**Table 1: Responses to Comments from Government Department on Planning Application No. A/NE-LYT/816 (29 February, 2024)**

Figure 4B

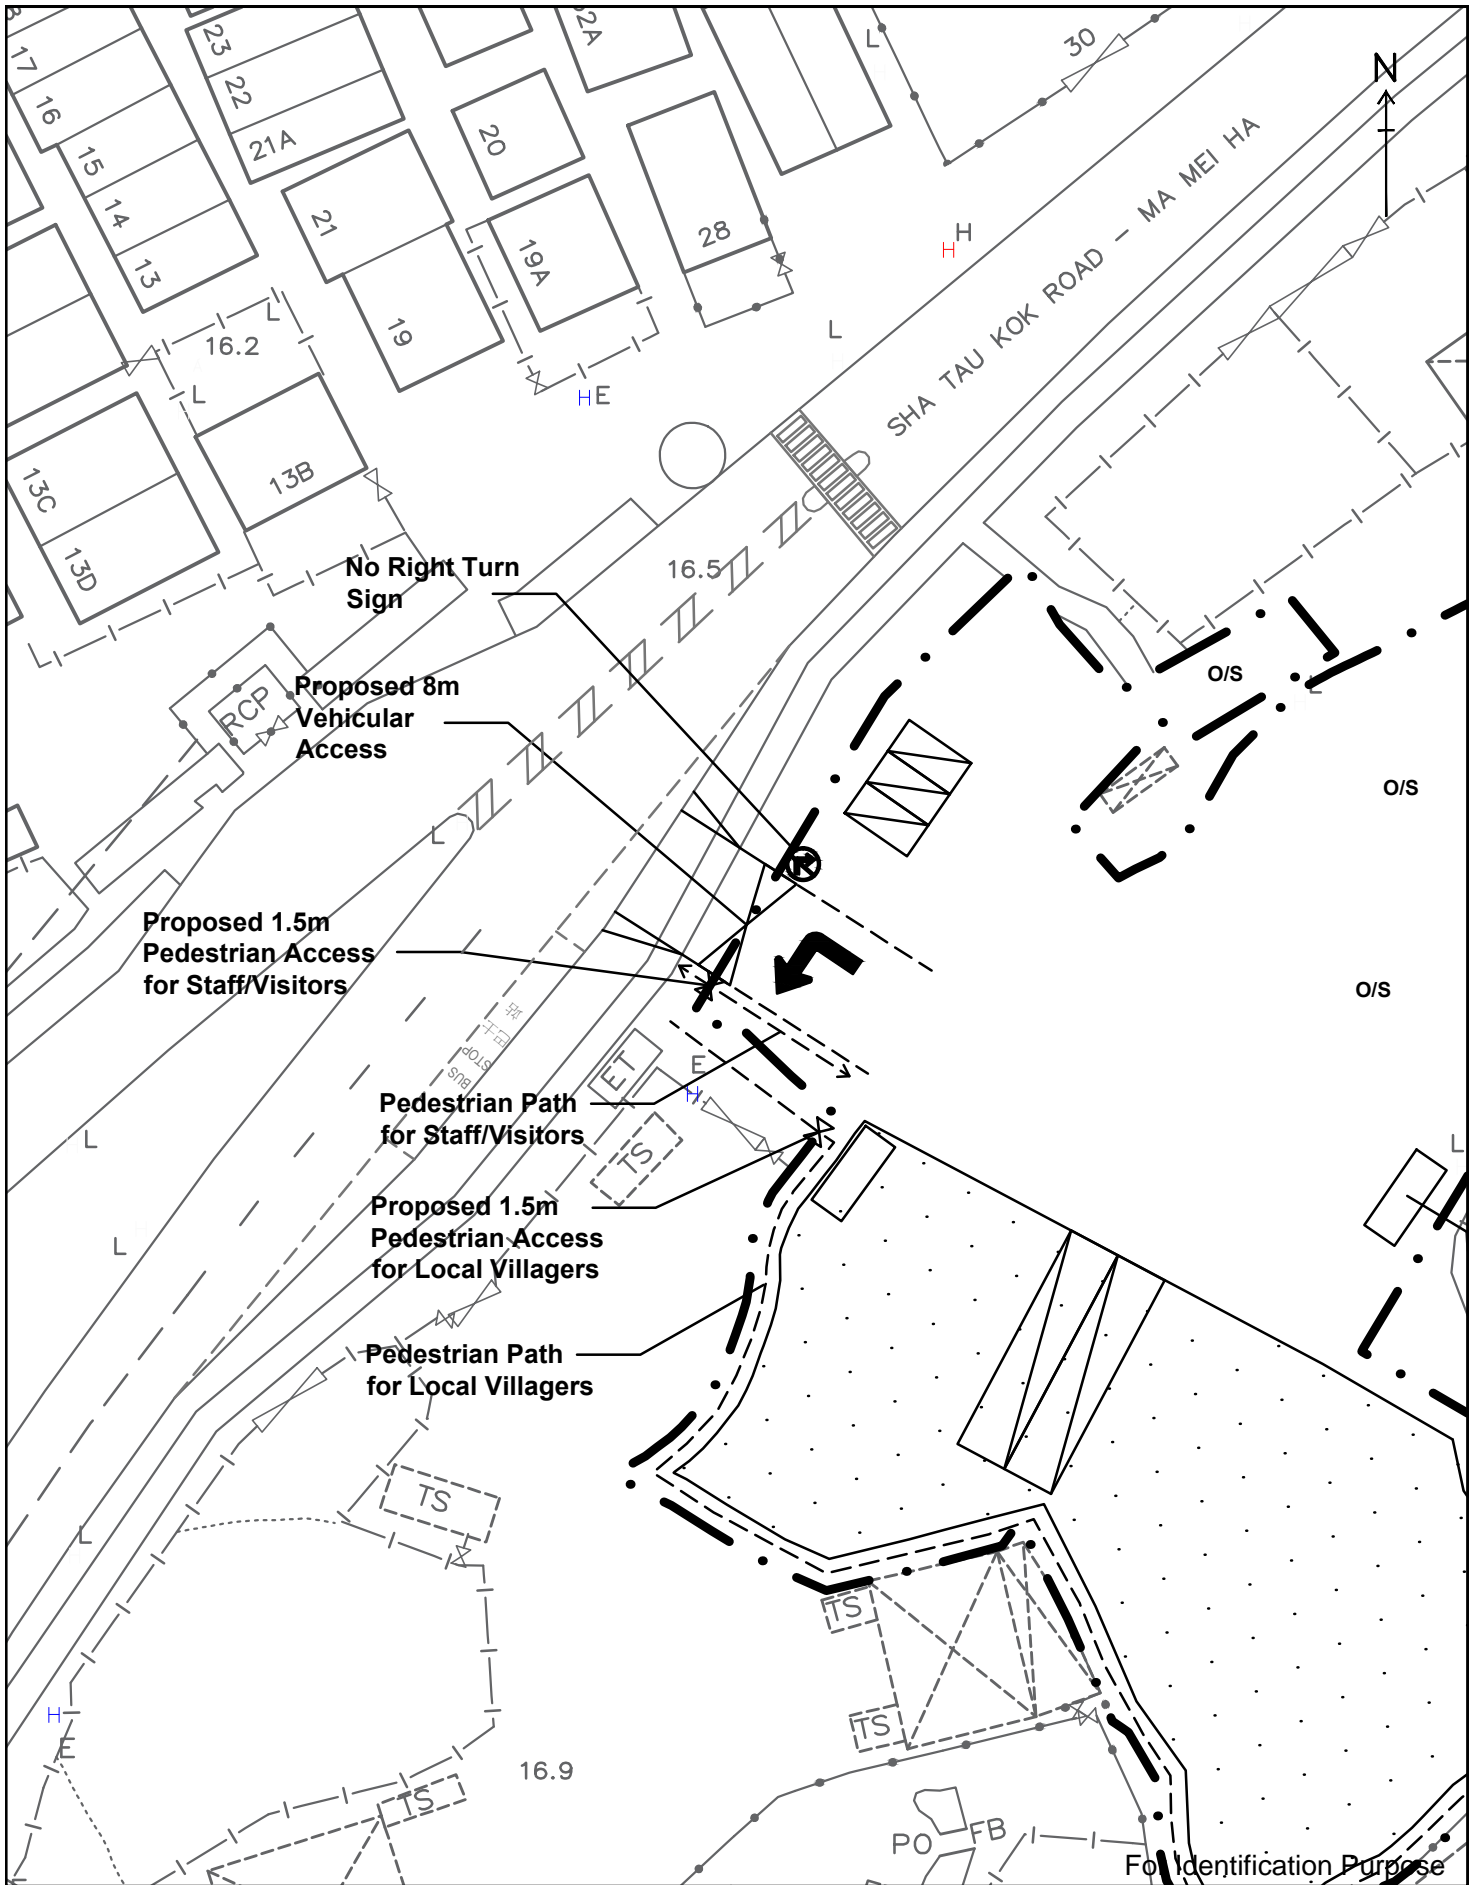
COMMENTS	RESPONSES
<b>1. Transport Department</b>	
(a) The applicant should clearly indicate the vehicular access of the proposed development in the drawing for our ease of reference and further review; and	(a) Please refer to the blow-up plan (see <b>Figure 4B</b> in <b>Annex 1</b> ) showing the vehicular access of the proposed development. The proposed vehicular access is 8m wide and all vehicles from the run in/out will be restricted to “Left Turn” only.

(c) Referring to response-to-comment table Item 4(b), please advise and illustrate on plan what measures would be adopted to restrict the vehicles leaving the site to left turning only;	(c) A left-turn road sign will be marked on the entrance of the ground and a “No right-turn” sign will be posted at a prominent location of the entrance to restrict the vehicles leaving the site to left turning only (see <b>Figure 4B</b> in <b>Annex 1</b> ).

Figure 4C

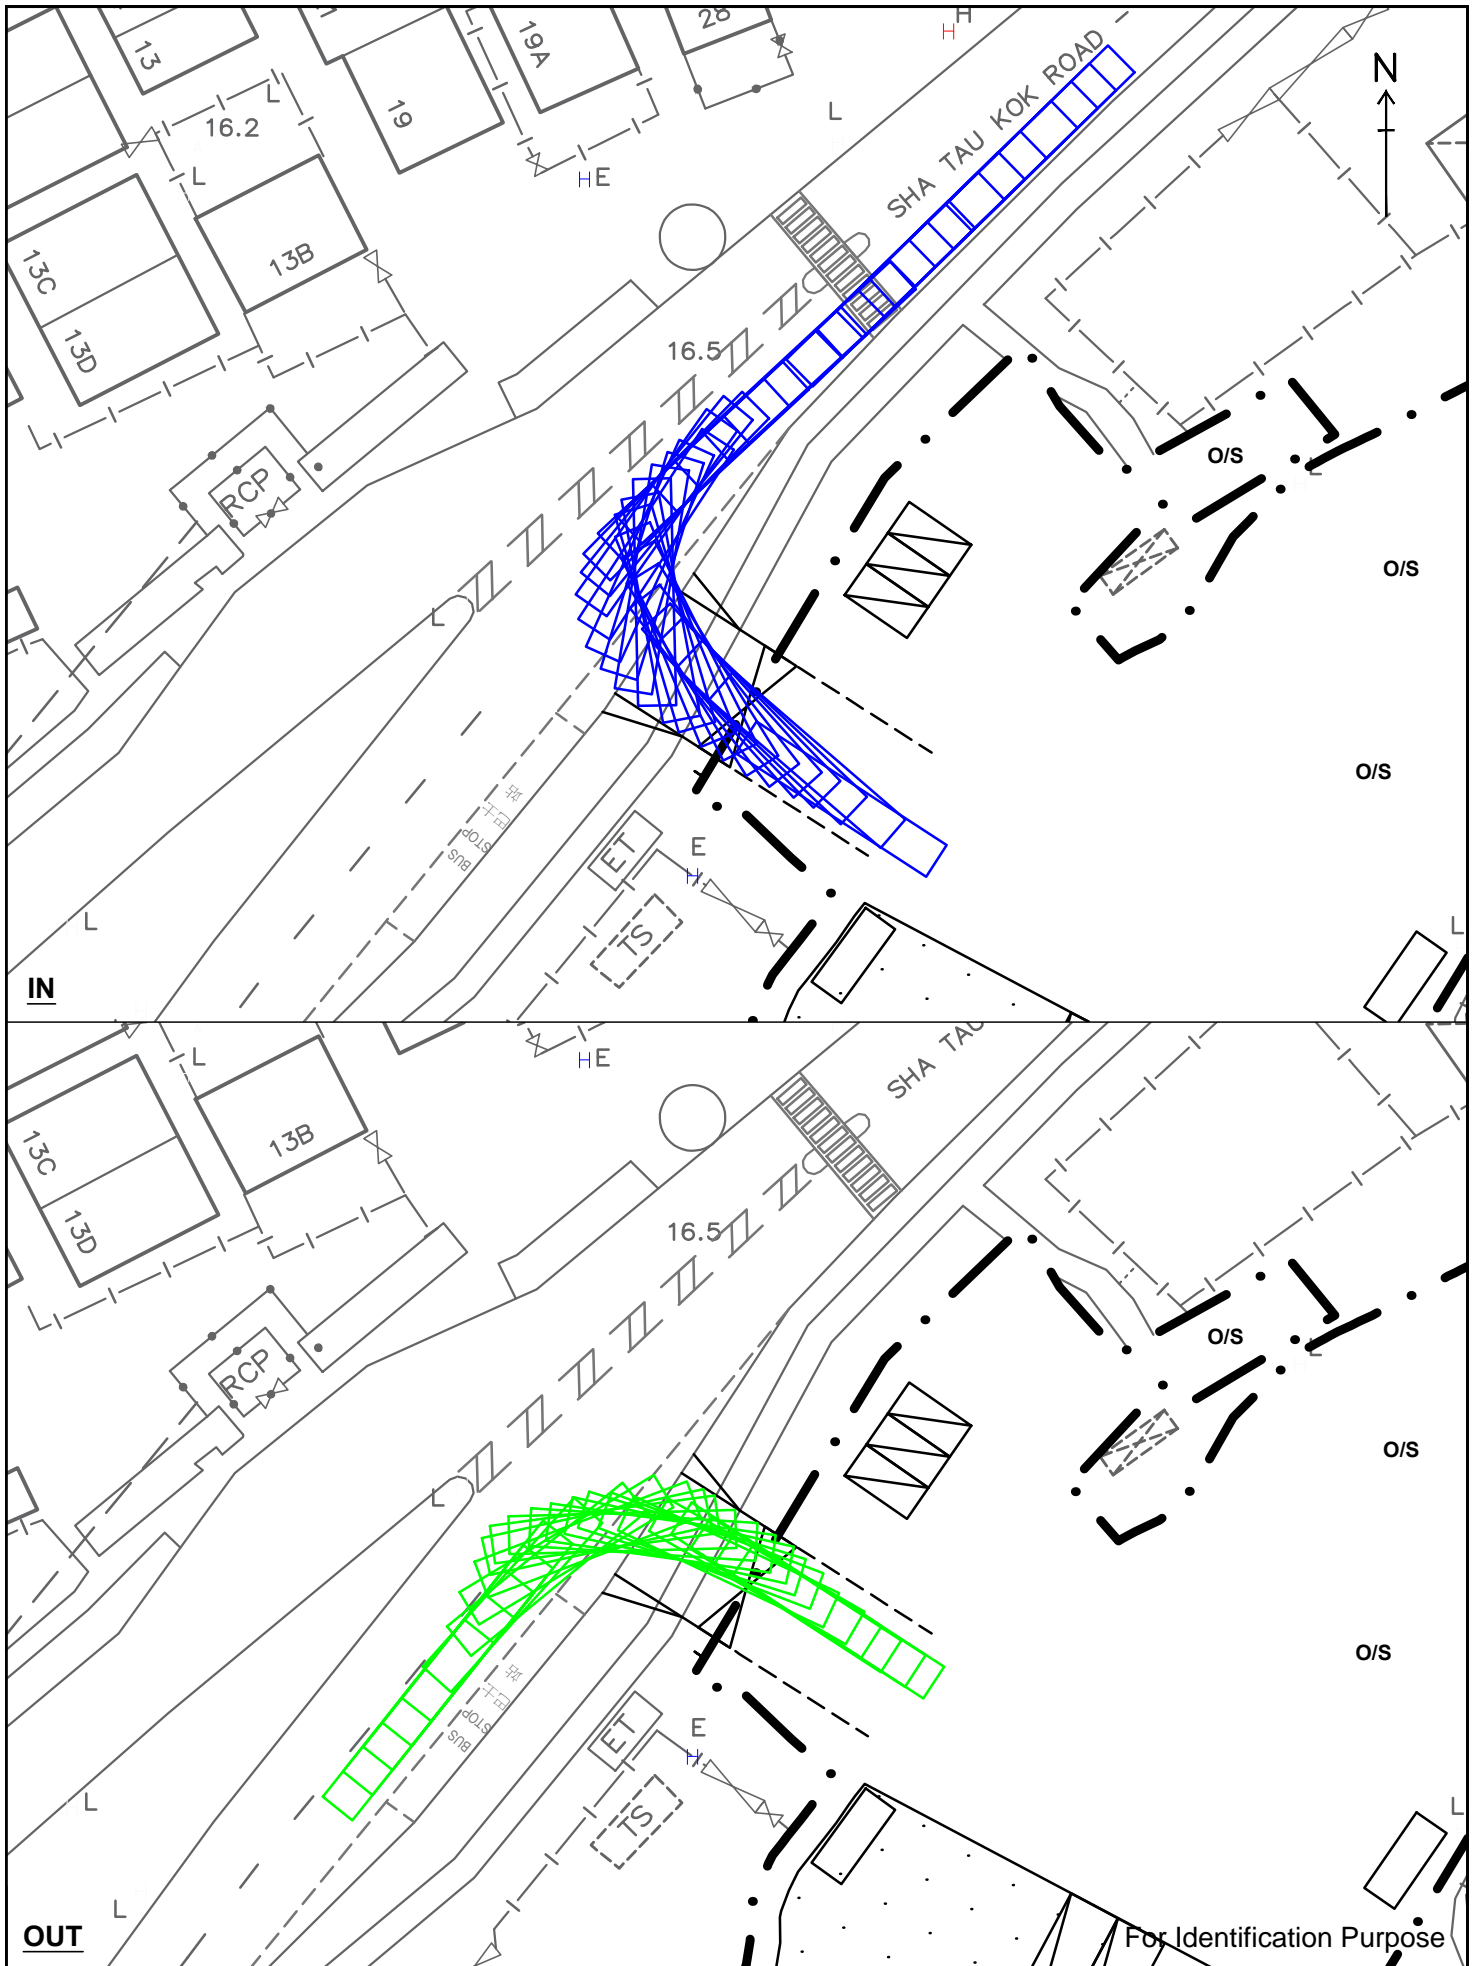
(b) Based on the documents and drawing available at the moment, it seems that the vehicular access of the proposed development is close to the existing crossing with islands and the bus stop (southbound) on Sha Tau Kok Road - Ma Mei Ha. The applicant should further demonstrate how the pedestrian, traffic and transport operation would not be affected for our further consideration.	(b) According to the swept path analysis for heavy goods vehicle attached (see <b>Figure 4C</b> in <b>Annex 1</b> ), the getting in/out of vehicles will not affect the existing crossing with islands and the bus stop (southbound) on Sha Tau Kok Road – Ma Mei Ha. A pedestrian path for staff and visitors of 1.5m will be provided at the southwest side of the vehicular access. Another pedestrian access/path will also be reserved along the southwestern boundary within the Application Site for local villagers from Sha Tau Kok Road – Ma Mei Ha to the village settlements in Ng Uk Tsuen. As such, the Applicant will provide separate vehicular and pedestrian access to ensure pedestrian safety.

**Figure 4D Section**

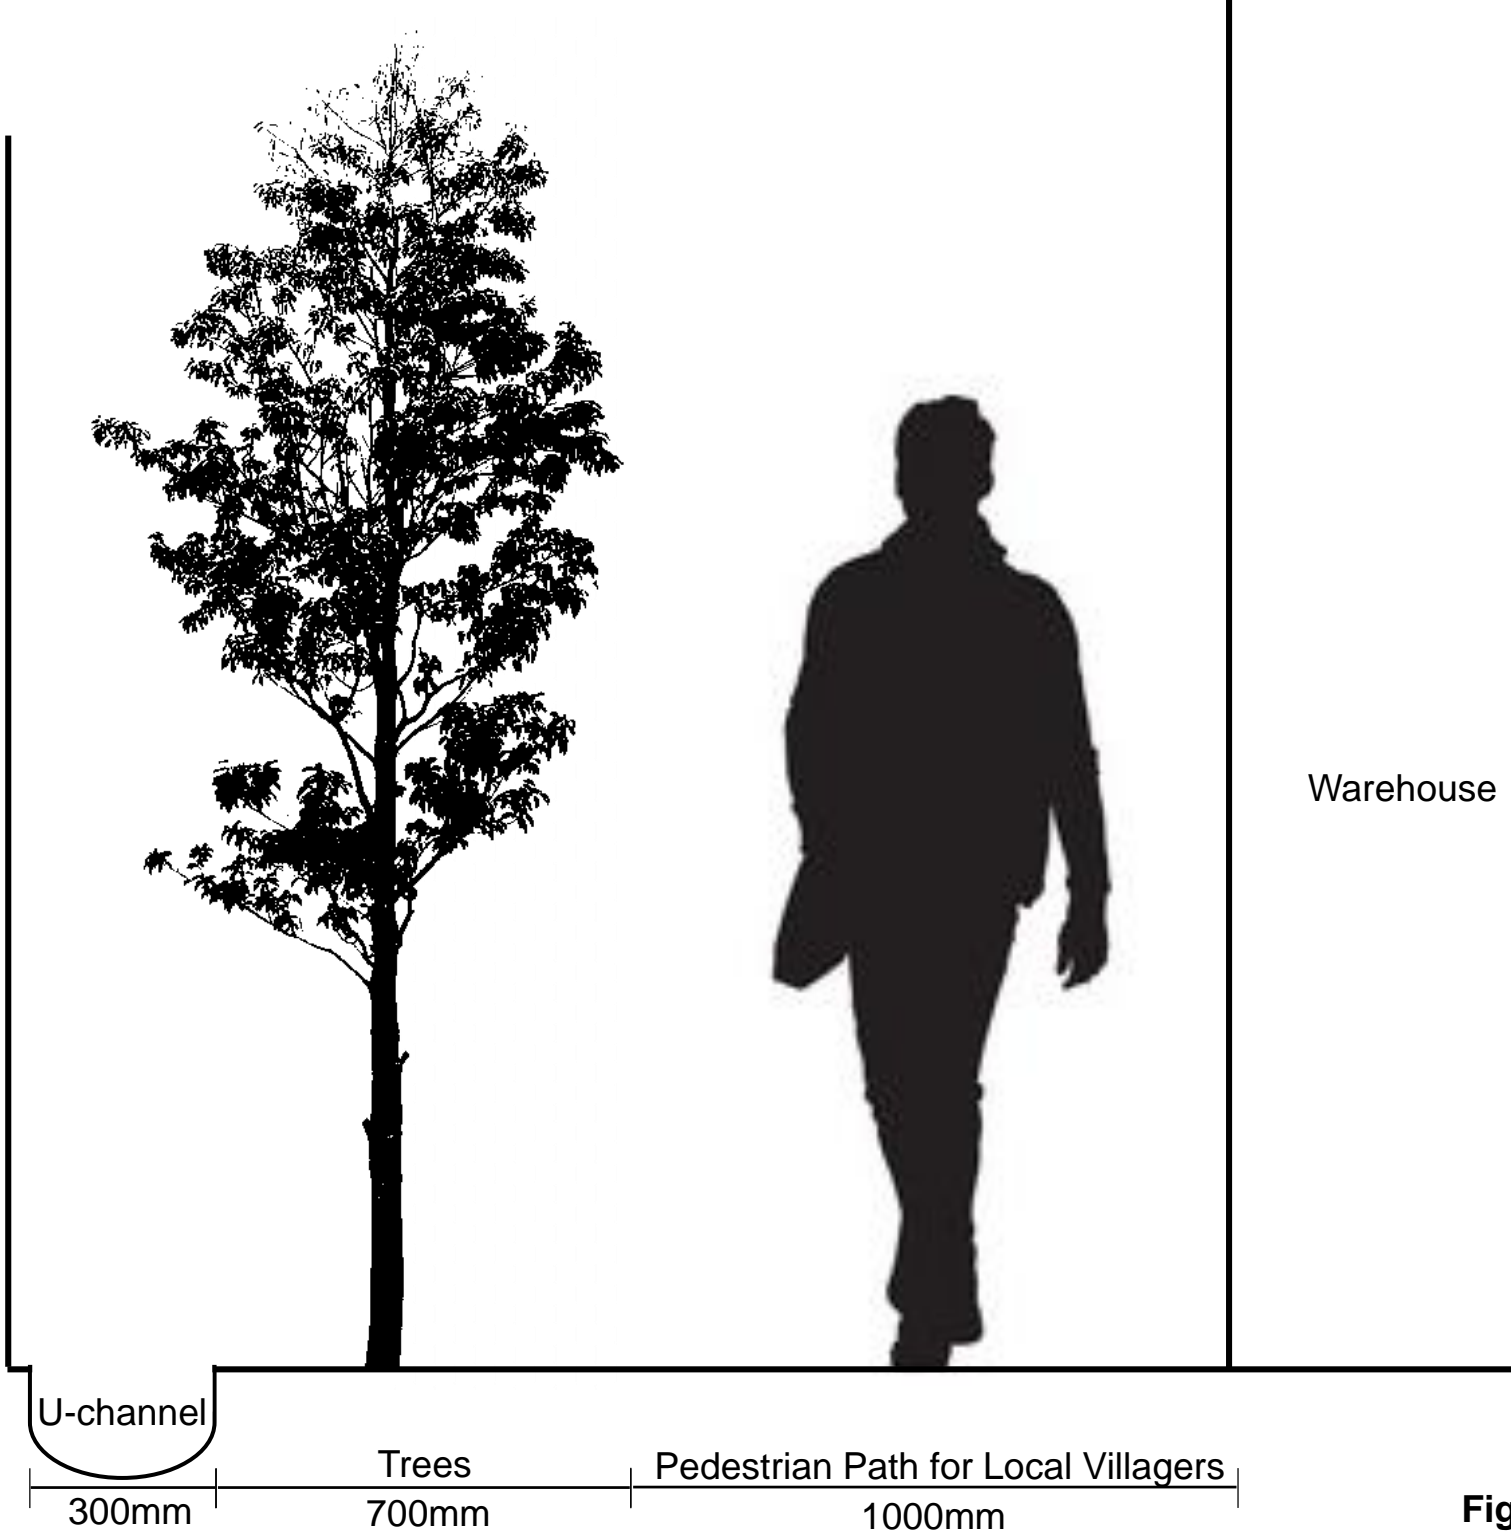
(d) Referring to the Layout Plan in Annex 1, please state the clear width of the proposed pedestrian path for local villagers and justify whether the clear width is sufficient for local villagers.	(d) The Applicant will reserve a pedestrian path of not less than 1m for local villagers and the warehouse will be set back to allow sufficient space for local villagers. The width of this pedestrian path is similar to the width of existing footpath outside the Application Site leading to Ng Uk Tsuen.

COMMENTS	RESPONSES
(e) Referring to the plan for the Landscape and Tree Preservation Proposal in Annex 2, please clarify whether the existing trees at the western side of the land lot will clash with the proposed pedestrian path.	(e) The Applicant will reserve a pedestrian path of not less than 1m for local villagers. As such, the pedestrian path for local villagers will not clash with the existing trees (see Section in <b>Figure 4D</b> attached).

# Viewing Points of Tree Photos

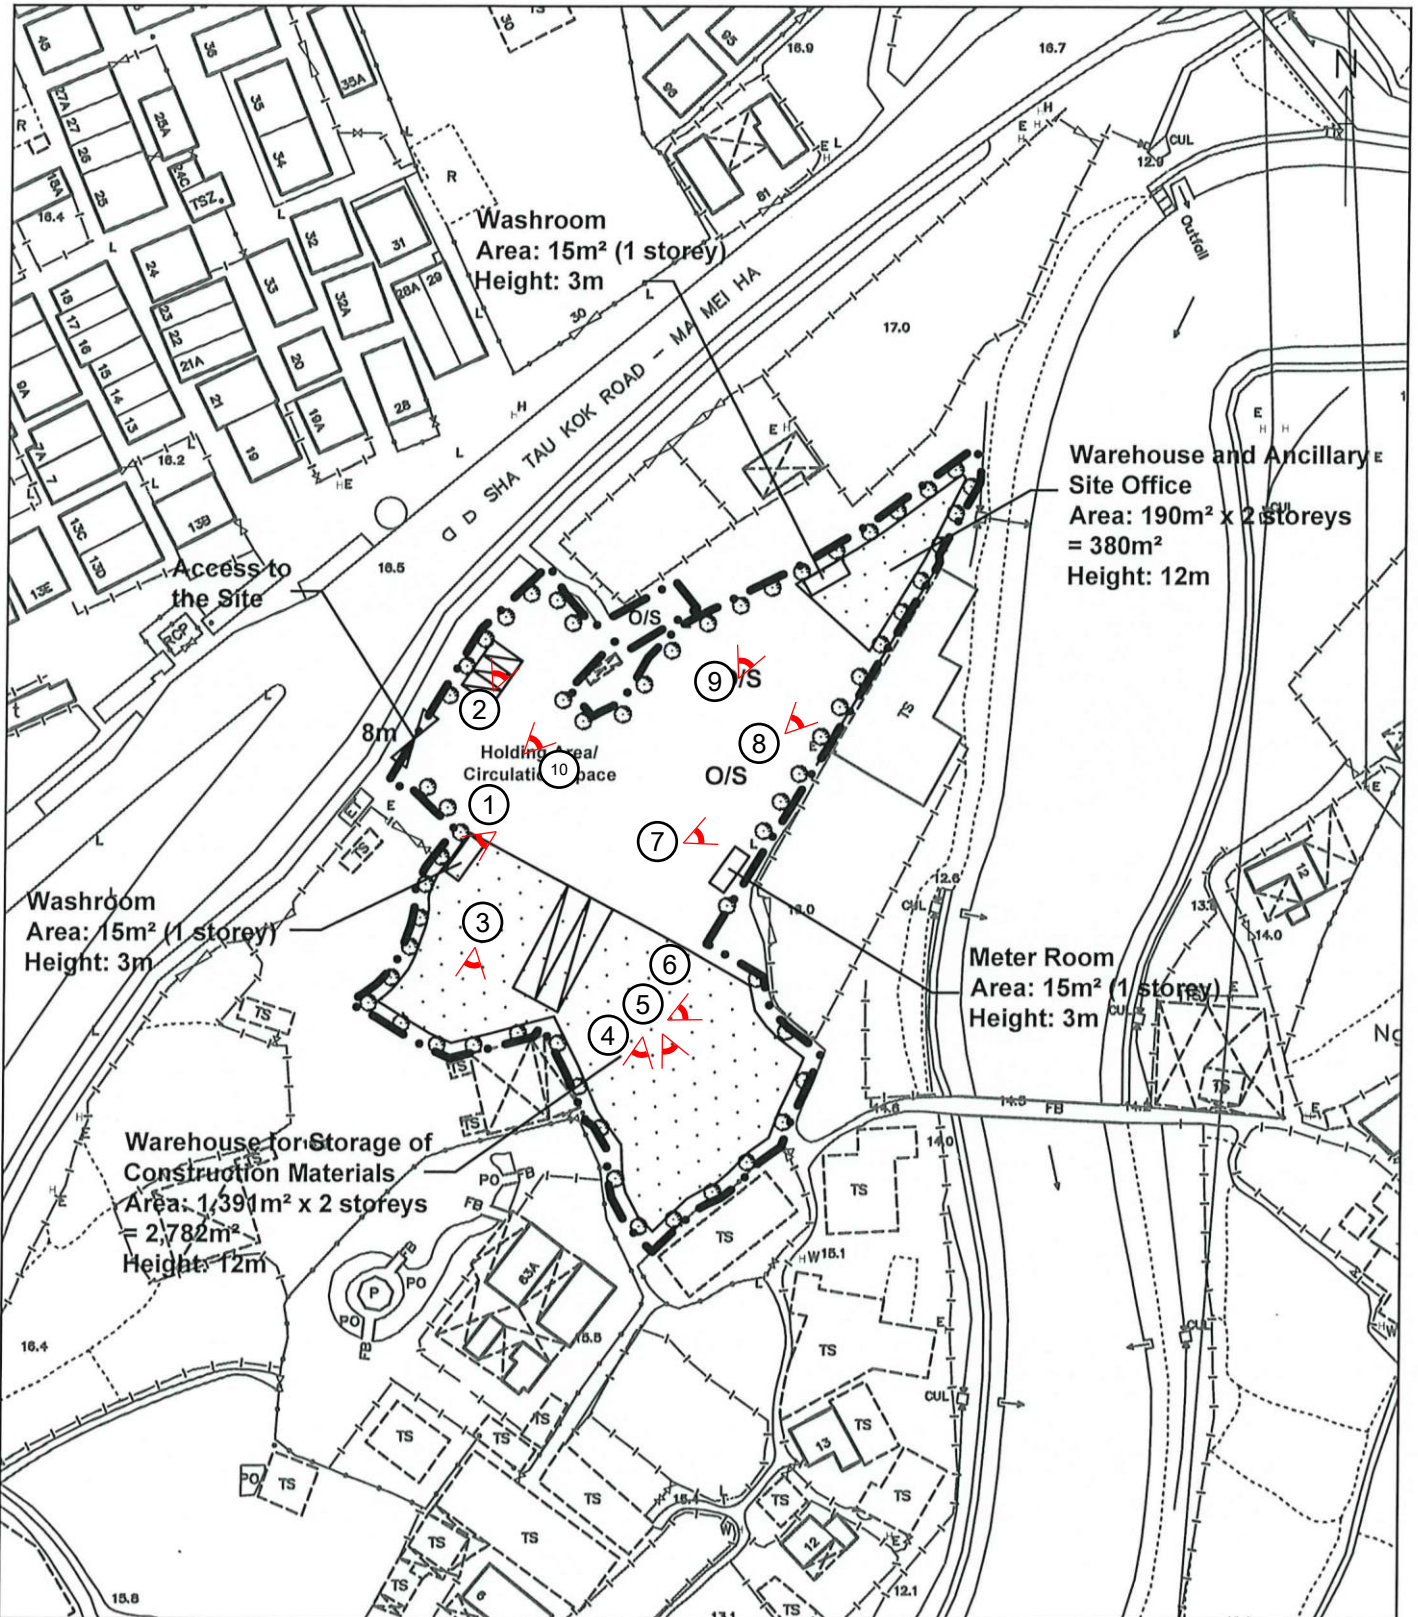
(b) The applicant is advised to indicate the viewpoint location and angle of the provided tree photos in Annex 2.	(b) The viewpoint location and angle of the tree photos are provided in <b>Annex 2</b> attached.
